CERTIFICATE OF APPROPRIATENESS

Applicant: Alan Stilts, PBK Architects for Jim McShane, owner

Property: 1505 South Blvd, Lot 5, Tract 6A Broadacres Subdivision. The property includes a historic 6,700 square foot, two-story brick single-family house with a detached garage situated on a 79,870 square foot interior lot.

Proposal: Alteration - Remove all wood 1-over-1 and casement windows and non-original wood doors on the residence and replace with 1-over-1 and casement wood windows and doors with 5/8" insulated glazing.

WINDOW DAMAGE

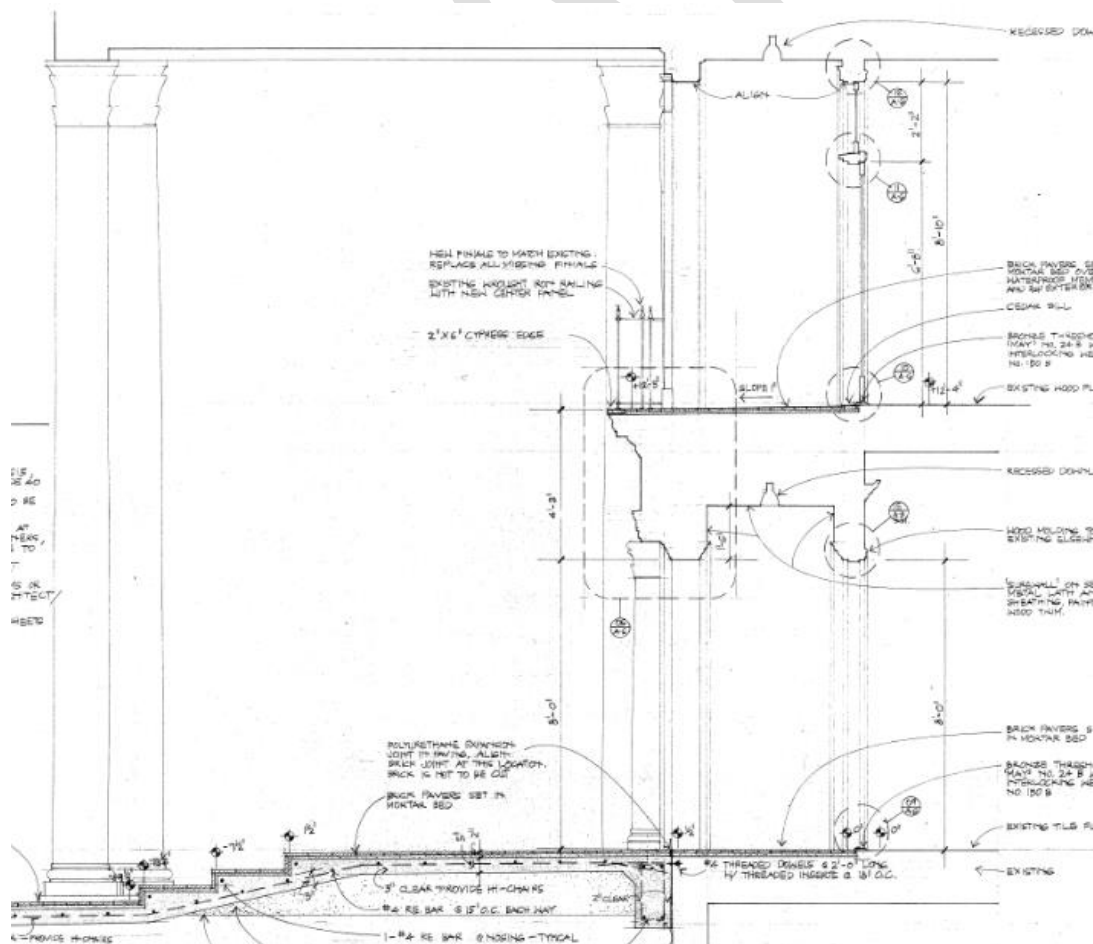
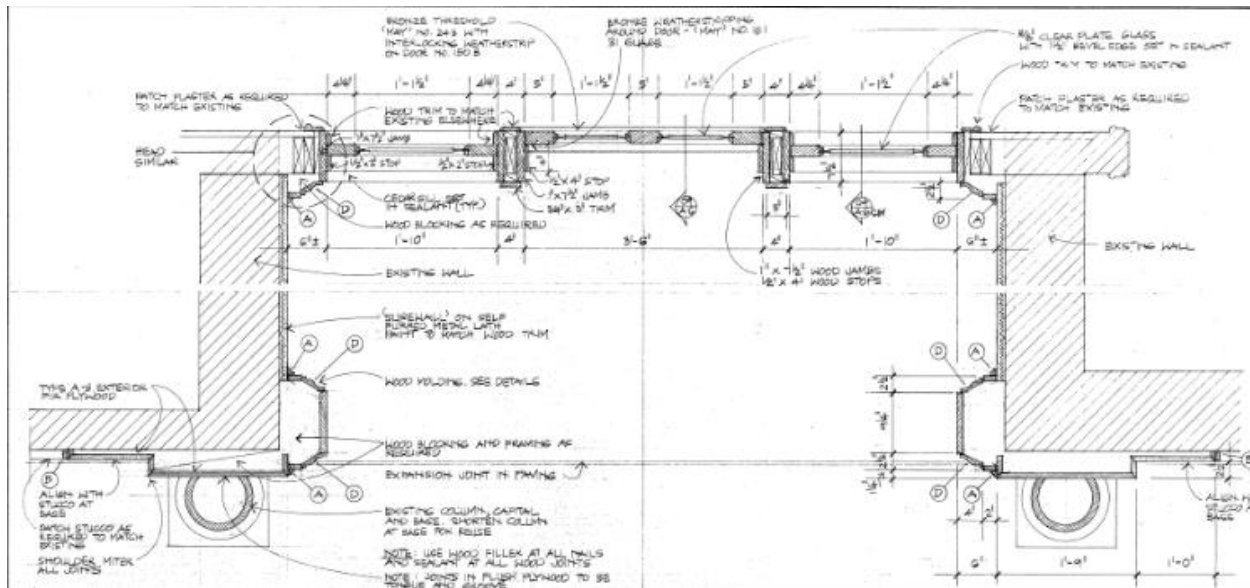
<i>The original wood windows are distinguishing features of the property and should be retained. Staff confirmed that some windows had minor moisture damage, but were not damaged beyond repair.</i> |

<i>The original wood windows are distinguishing features of the property and should be retained. Staff confirmed that some windows had minor moisture damage, but were not damaged beyond repair..</i> |

Recommendation: Partial Approval: Approval to replace both first and second floor doors and denial to replace the original 1-over-1 and casement windows.
